ADDENDUM No. 1

RFP No. 26-29

Dexter Road Sidewalk and Stormwater Improvements

PAVEMENT MARKING & SIGNAGE - STA 6+00 TO STA 21+50

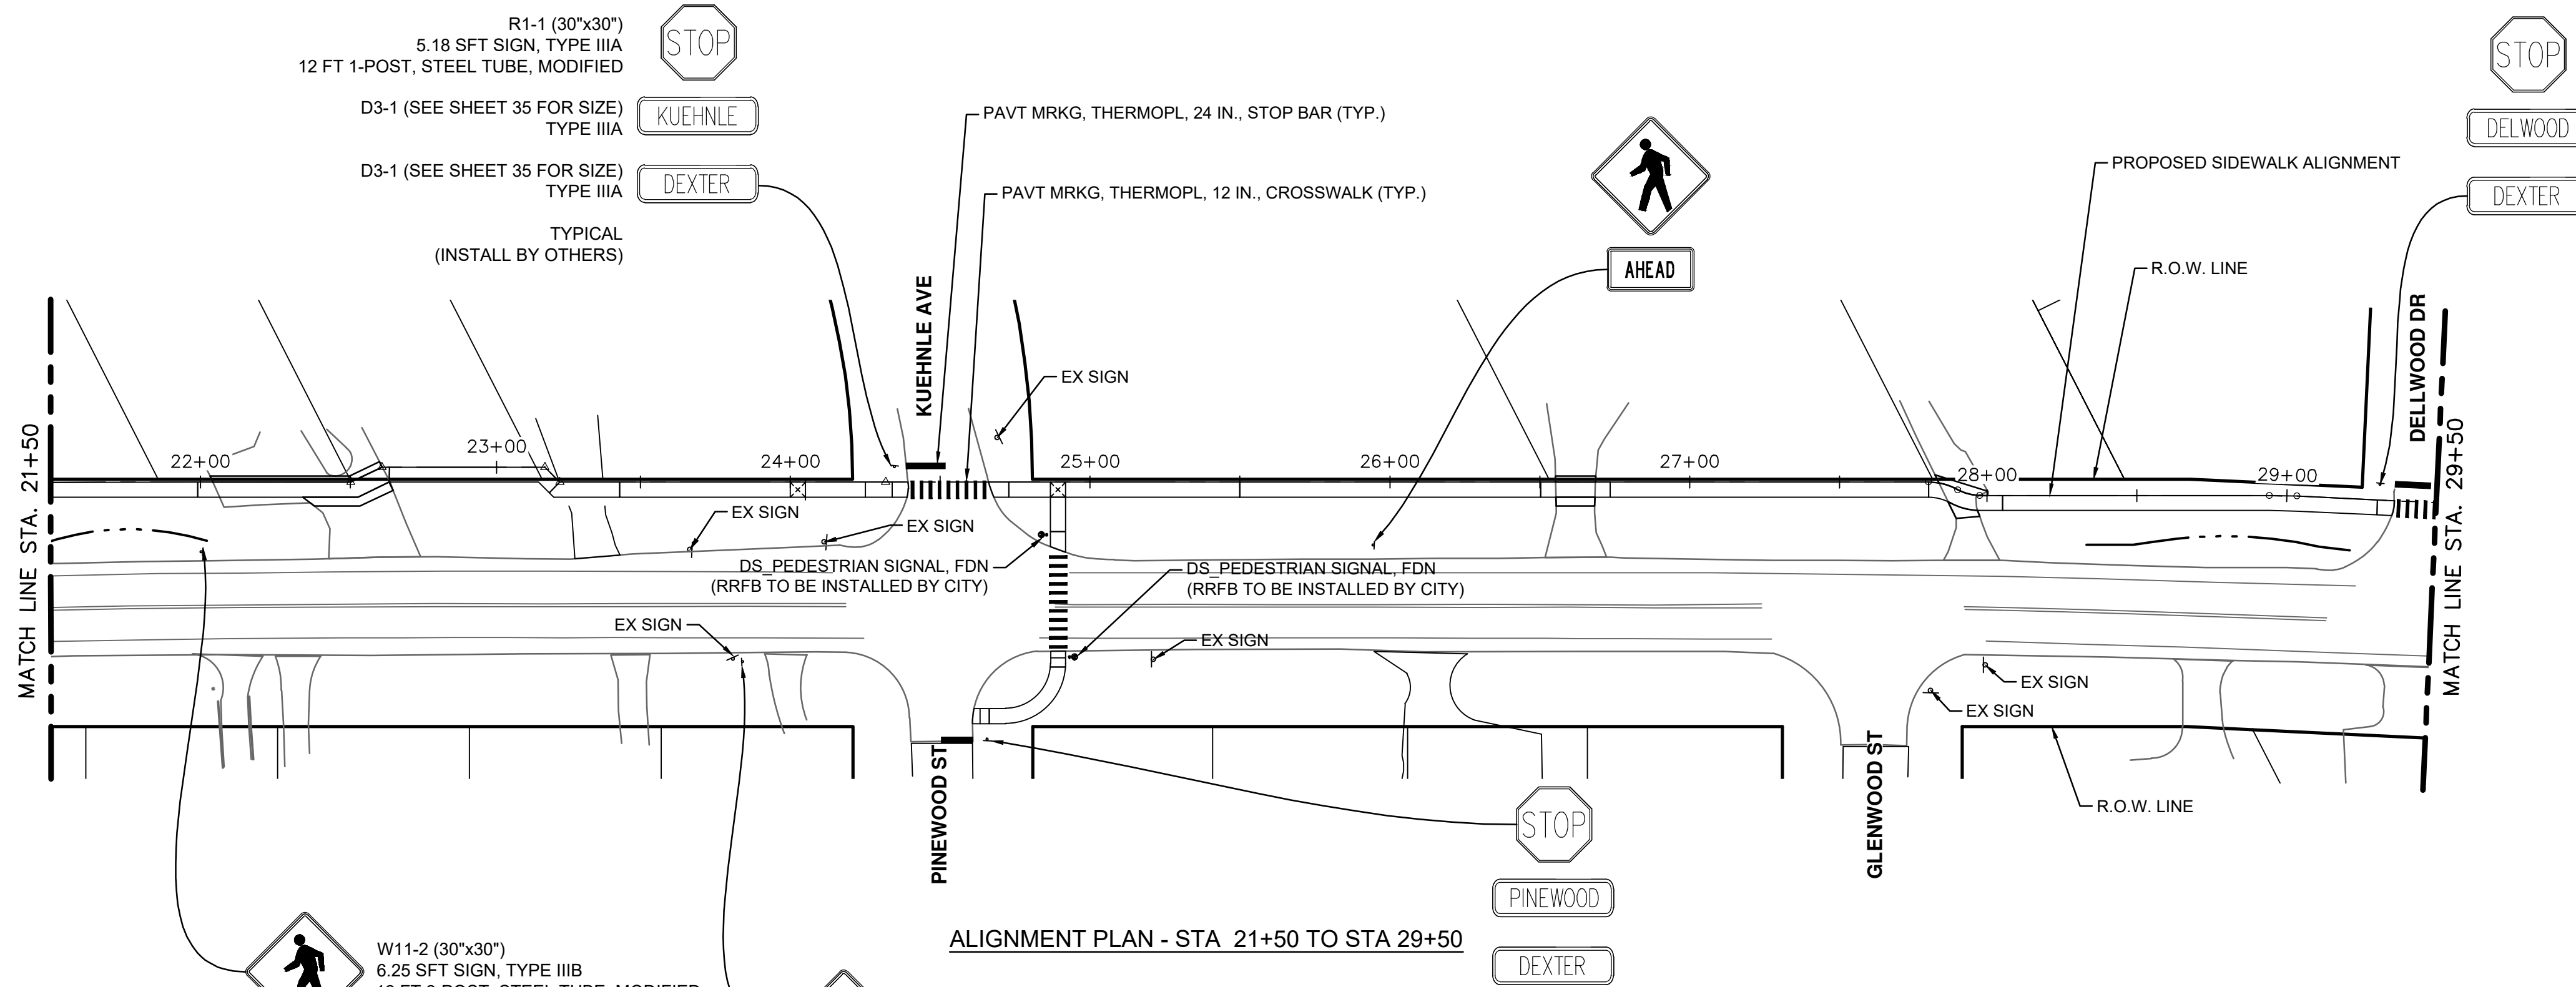
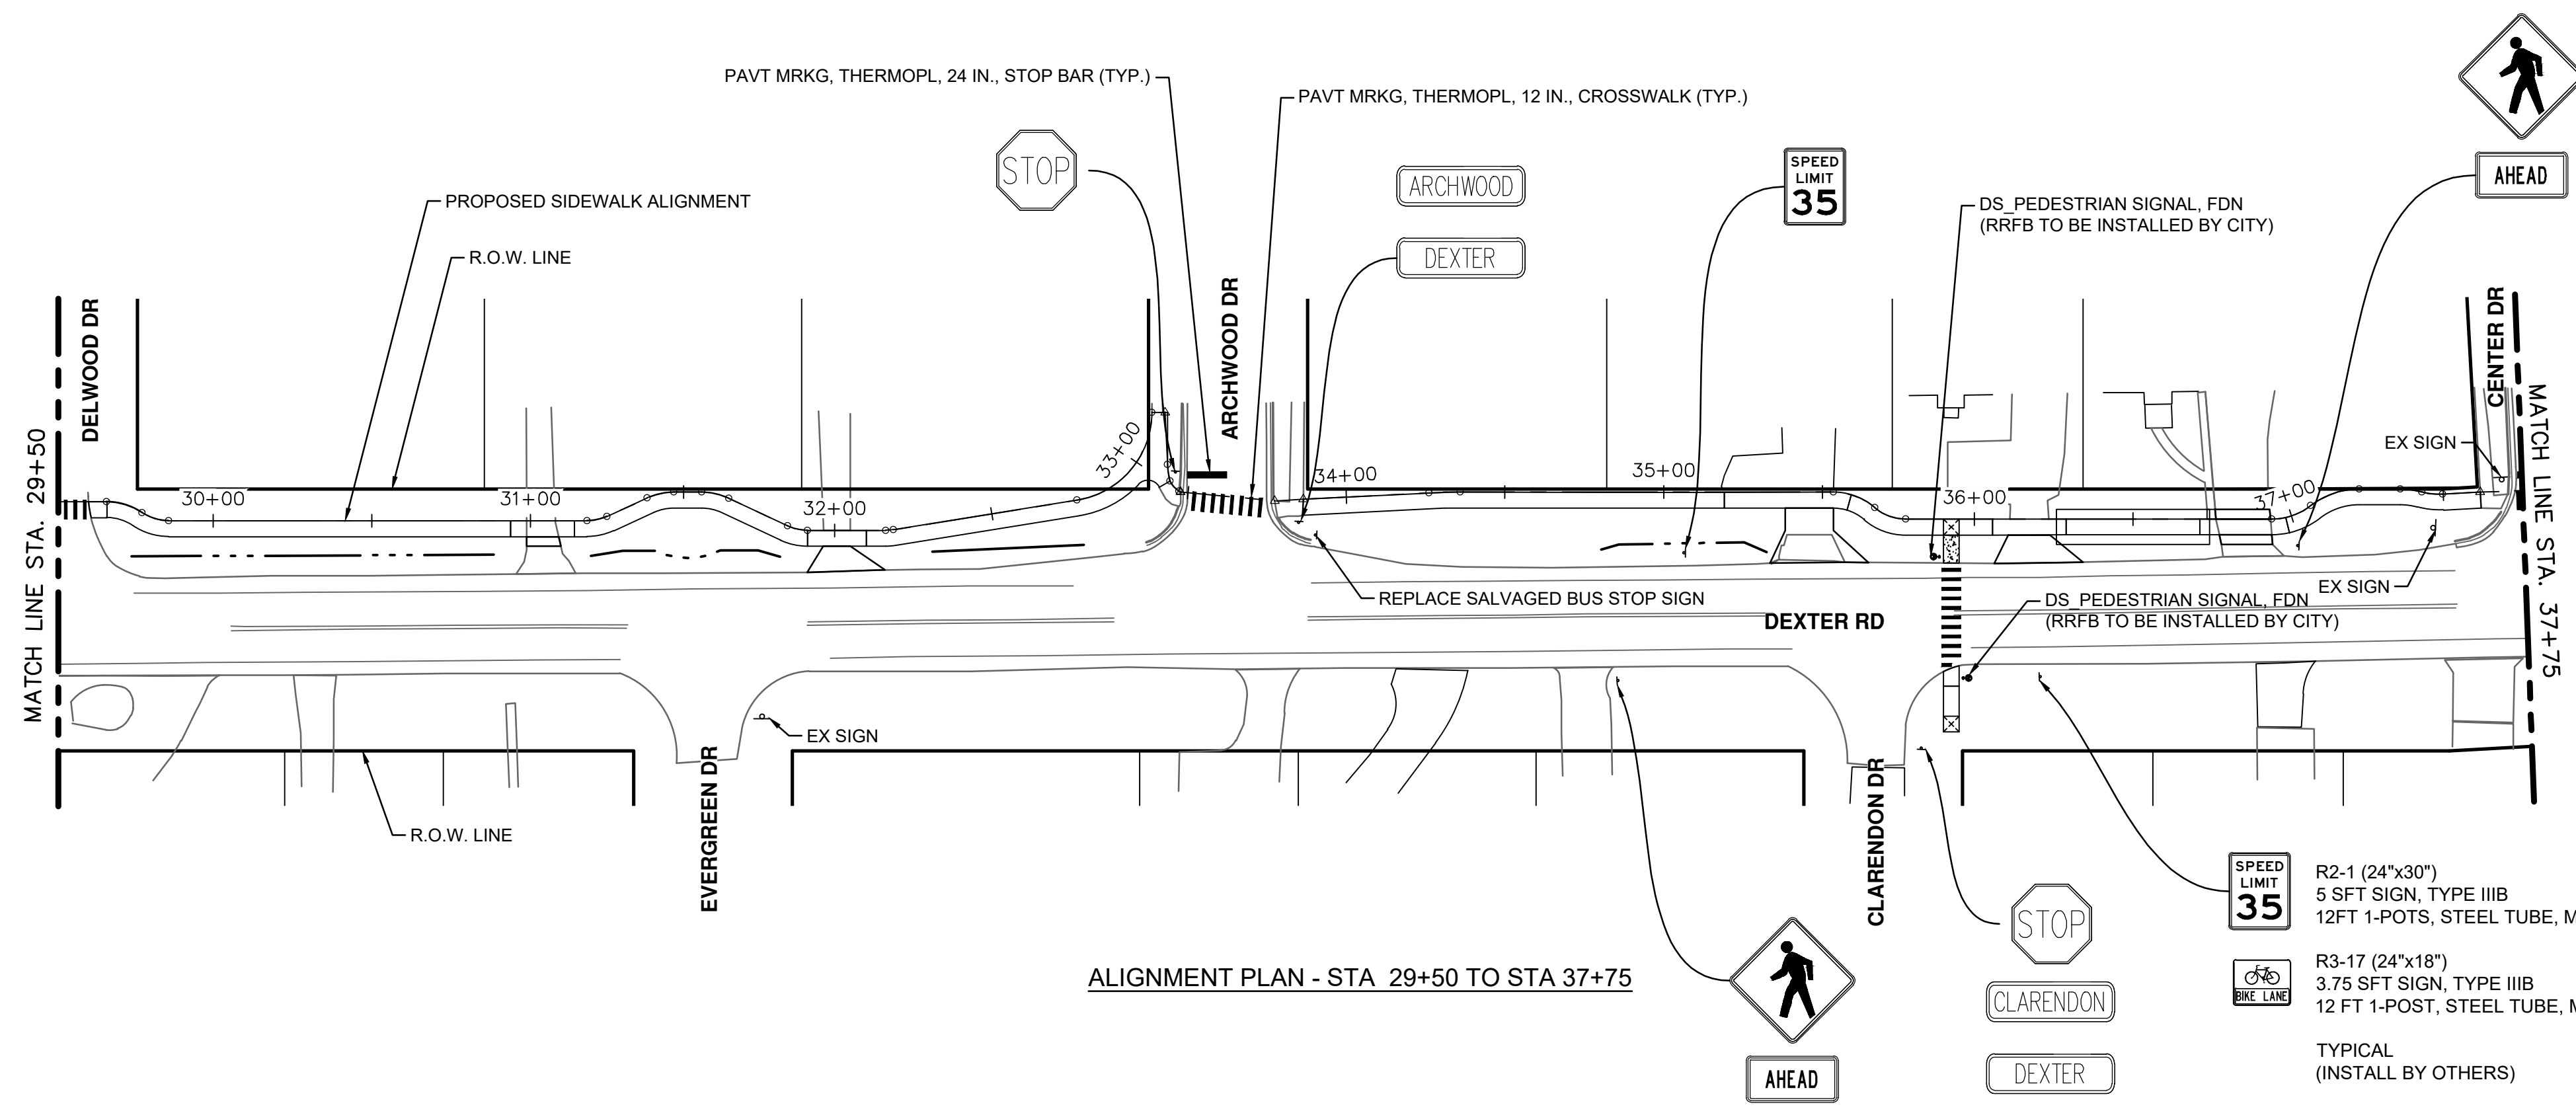
Revisions to call-out notations/labeling for signs and pavement markings, revised the “Pavement Marking Quantities – This Sheet” table to “Quantities – This Sheet” to reflect all applicable pay item and any updates, added quantity tables for “DS_Sign, Type IIIA – This Sheet” and “DS_Sign, Type IIIB – This Sheet”, revised the Rectangular Rapid Flashing Beacon detail/notes shown for reference, and added detailed fabrication information (plan sheet 35) for each of the Street Name (D3-1) sign being replaced.

MAINTENANCE OF TRAFFIC - PHASE 1: KUEHNLE AVE TO MAPLE RD
SCALE: 1" = 100'

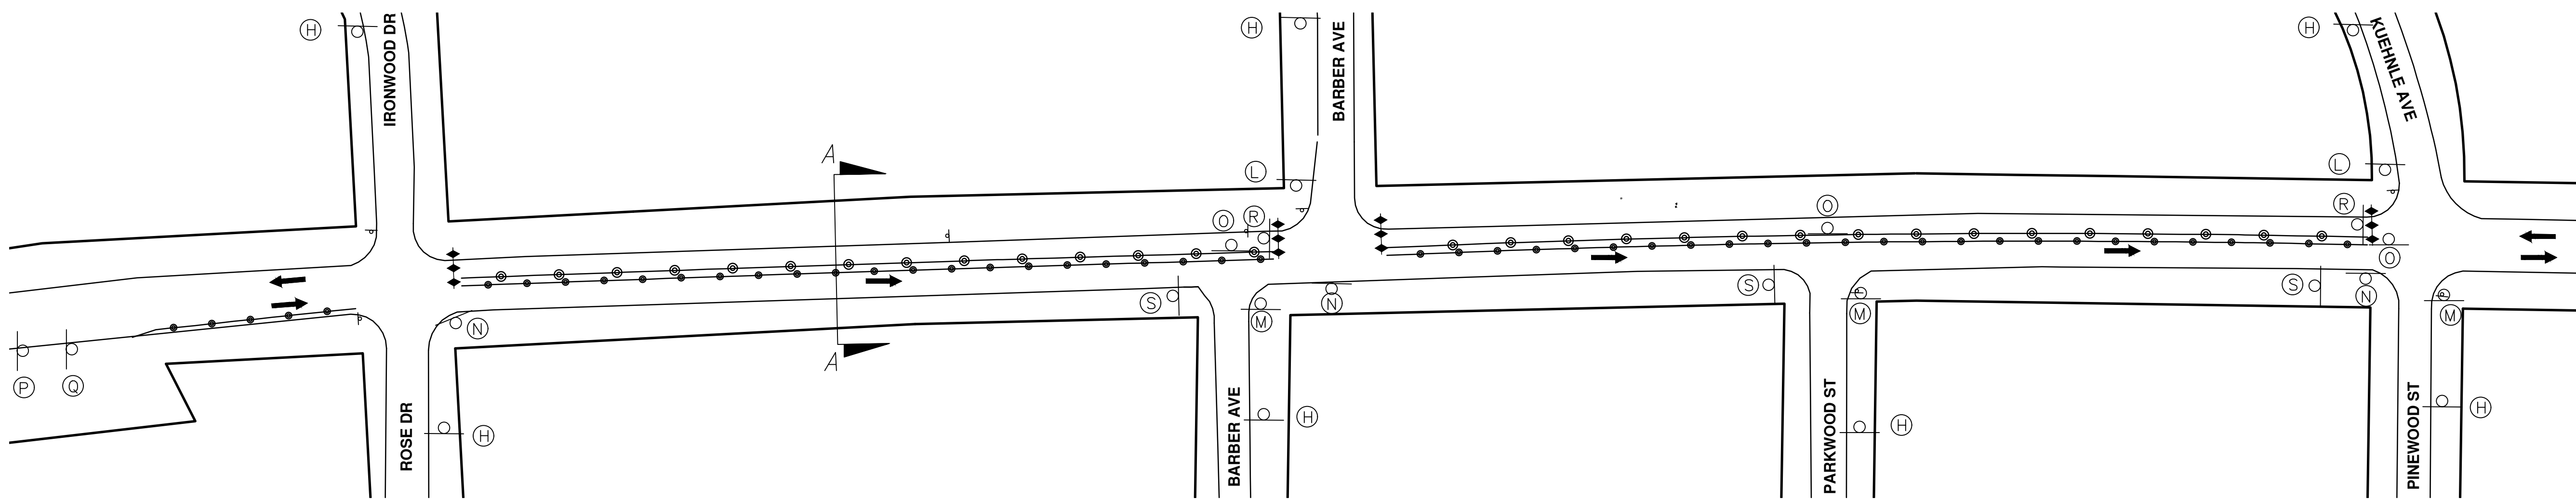
Created this new sheet to more clearly show the MOT requirements along Dexter Road for each of the construction phases.
